BIDDING ADDENDUM NO. 1

Park City Municipal Corporation  
HOMESTAKE ROAD STORM DRAIN IMPROVEMENTS

March 27, 2024

ADDENDUM NUMBER ONE  
TO  
CONTRACT DOCUMENTS, SPECIFICATIONS, AND DRAWINGS  
FOR  
HOMESTAKE ROAD STORM DRAIN IMPROVEMENTS

**HOMESTAKE ROAD STORM DRAIN**  
 PARK CITY, UTAH  
 PLAN & PROFILE

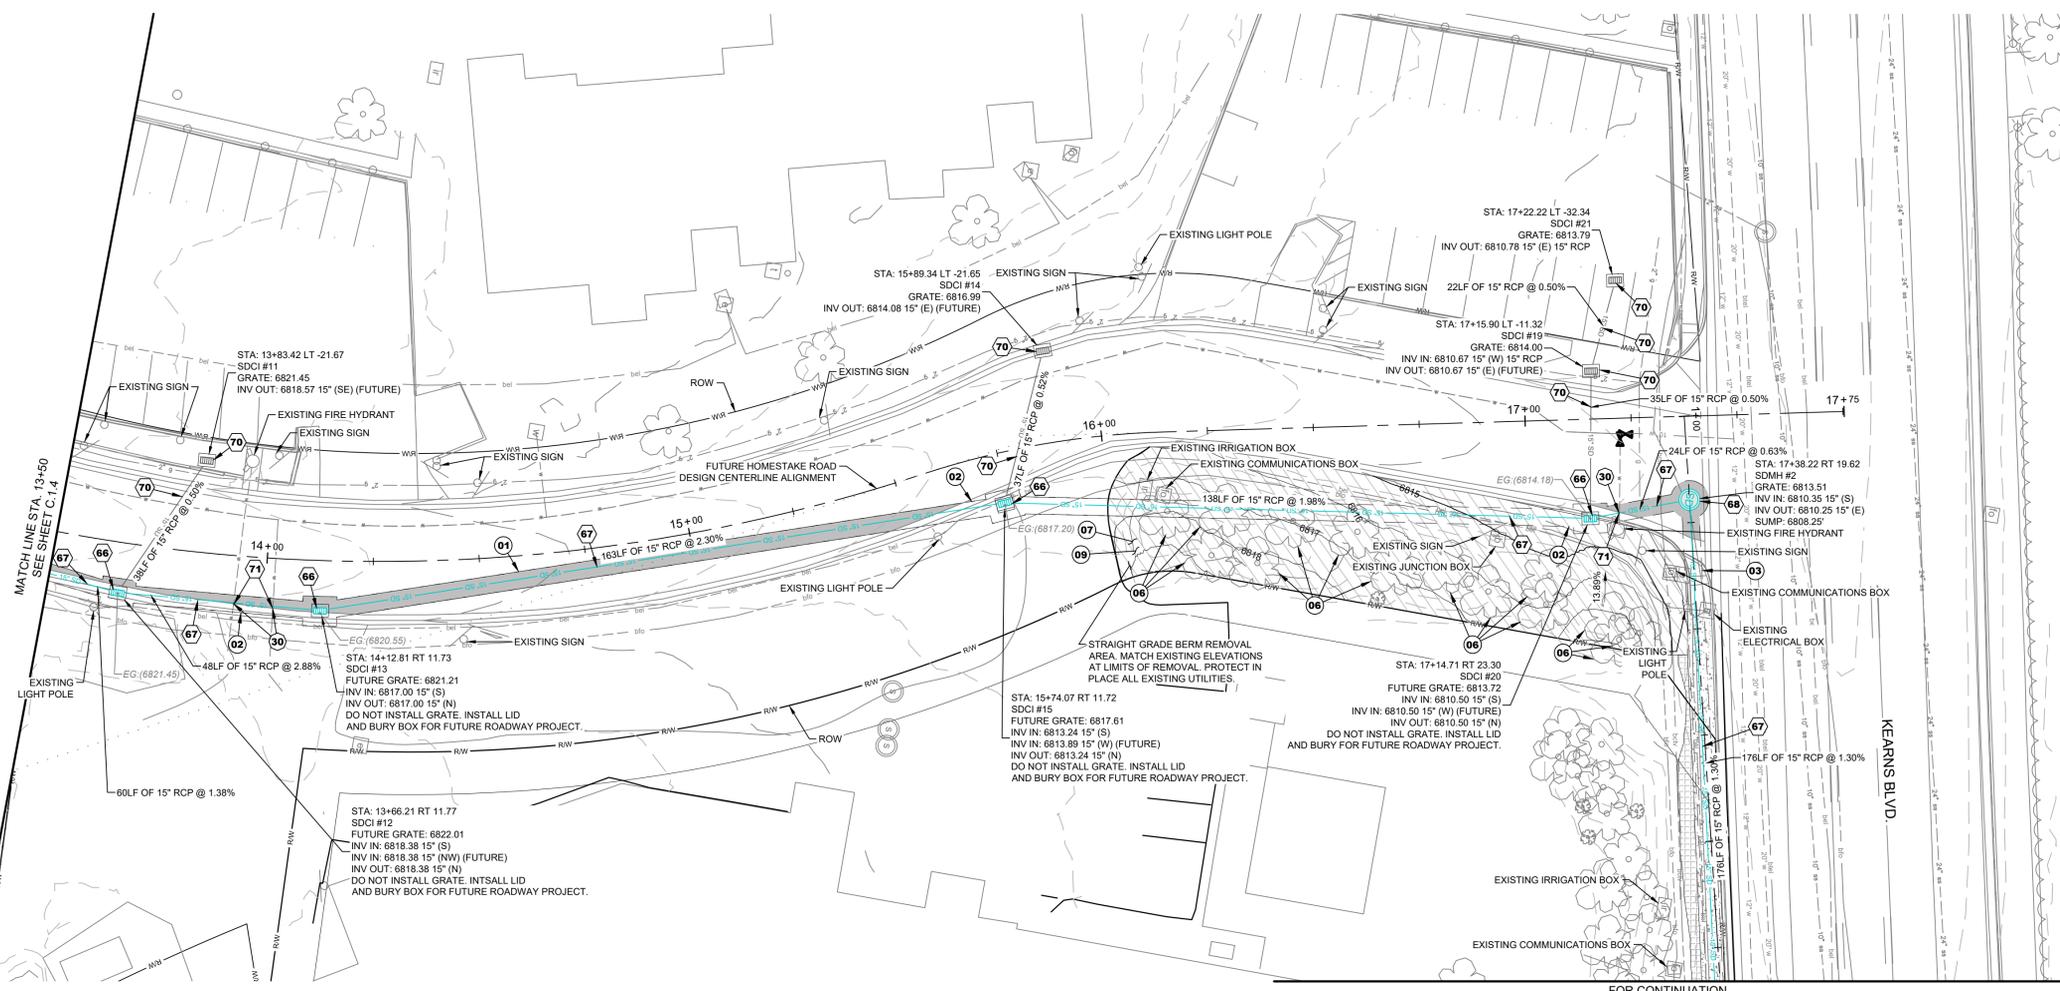
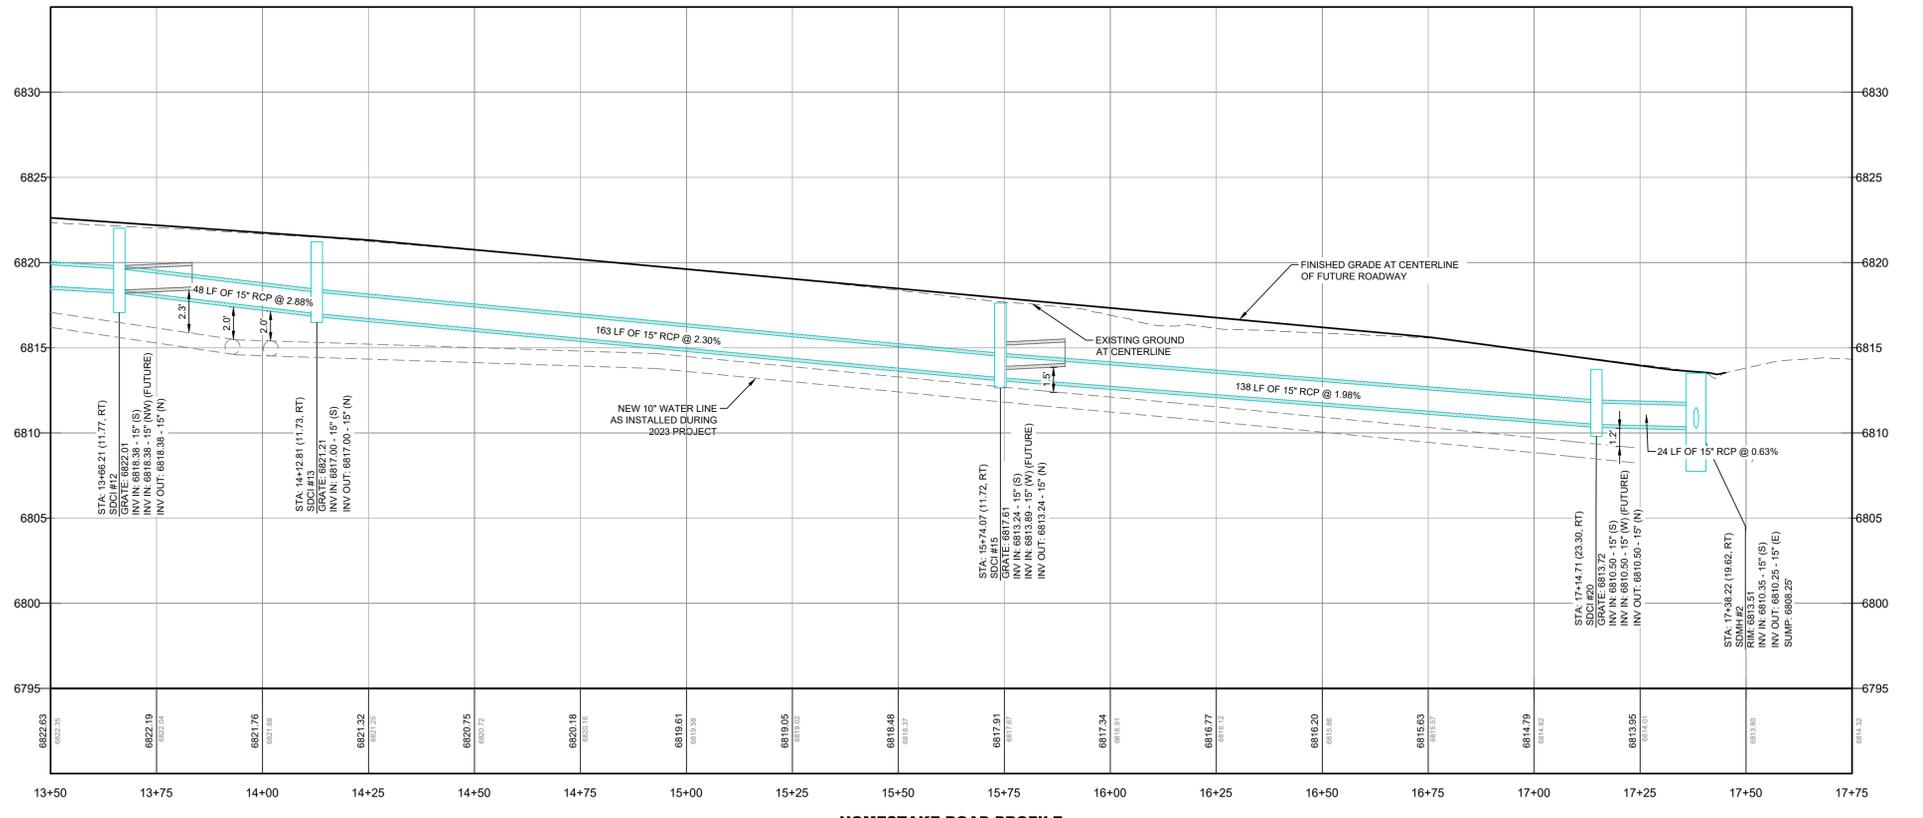
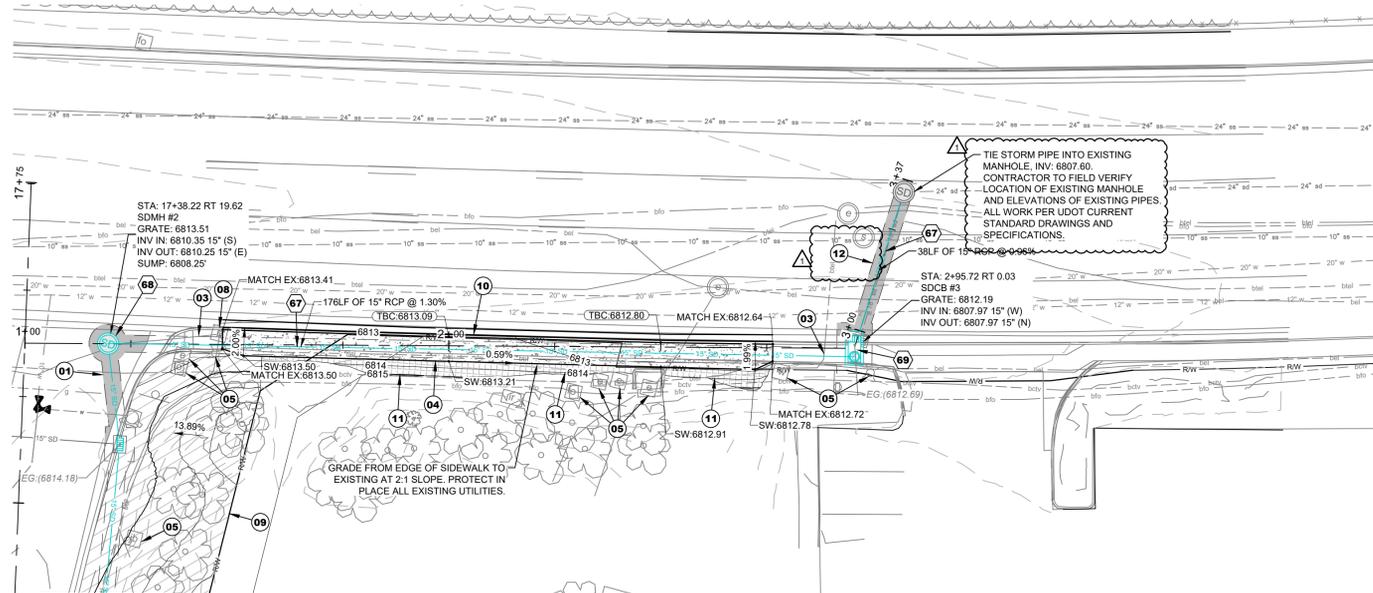
**5. SHEET C.1.5**

- a. Keynote modifications have been made to clarify where APWA standards vs. UDOT standards shall be used.

- REVEGETATE DISTURBED LANDSCAPE AREAS TO MATCH EXISTING CONDITION
  - SAWCUT AND PATCH ASPHALT PER CURRENT UDOT STANDARD DRAWINGS AND SPECIFICATIONS.

**C.1.6**  
 PAGE 10

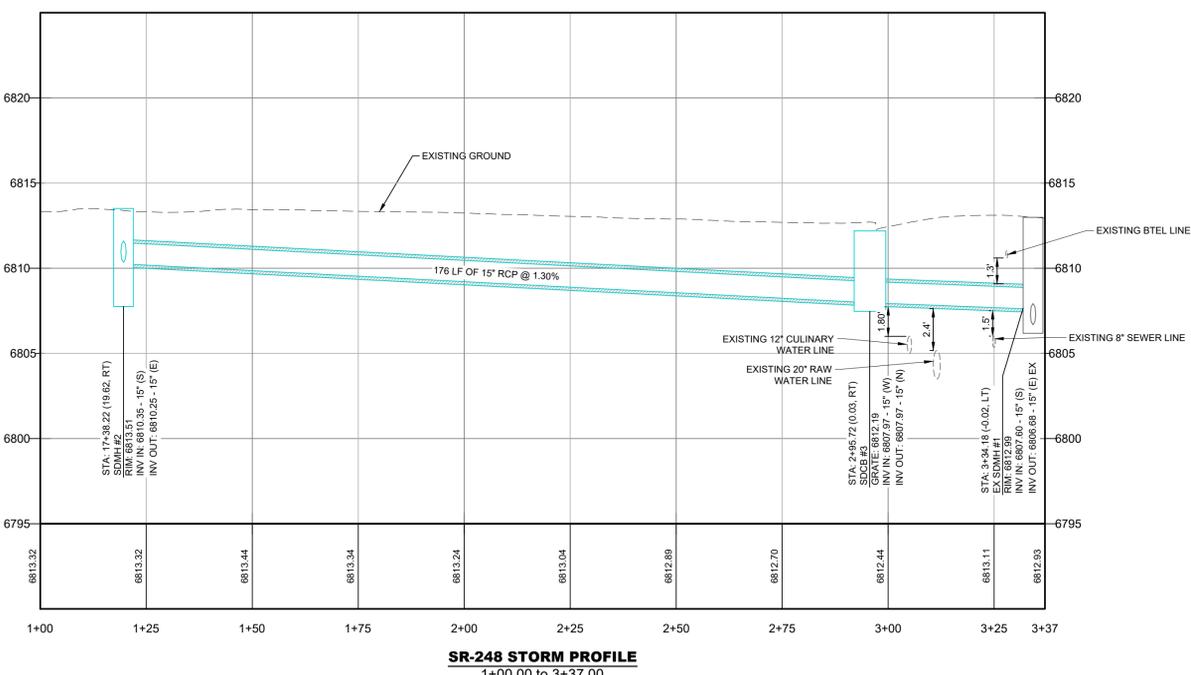
- a. **Question:** On page C.1.6, Keynote 1 refers to patching per APWA standards. This keynote points to the asphalt patch in the UDOT roadway SR-248. Should we plan to patch this per UDOT standards? Which bid item should the UDOT patching be included in?
- b. **Response:** Any work in UDOT's right-of-way shall comply with the current UDOT standard drawings and specifications. Revised sheet(s) have been included with the change to reflect this.

**6. SHEET C.1.6**

- a. Keynote modifications have been made to clarify where APWA standards vs. UDOT standards shall be used.

- 11 REVEGETATE DISTURBED LANDSCAPE AREAS TO MATCH EXISTING CONDITION
  - 12 SAWCUT AND PATCH ASPHALT PER CURRENT UDOT STANDARD DRAWINGS AND SPECIFICATIONS.

- 68 INSTALL NEW PRECAST MANHOLE PER APWA PLAN 341.2, SEE SHEET C.2.0. FOR MANHOLES LOCATED IN UDOT RIGHT-OF-WAY, CONSTRUCT PER CURRENT UDOT STANDARD DRAWINGS AND SPECIFICATIONS.
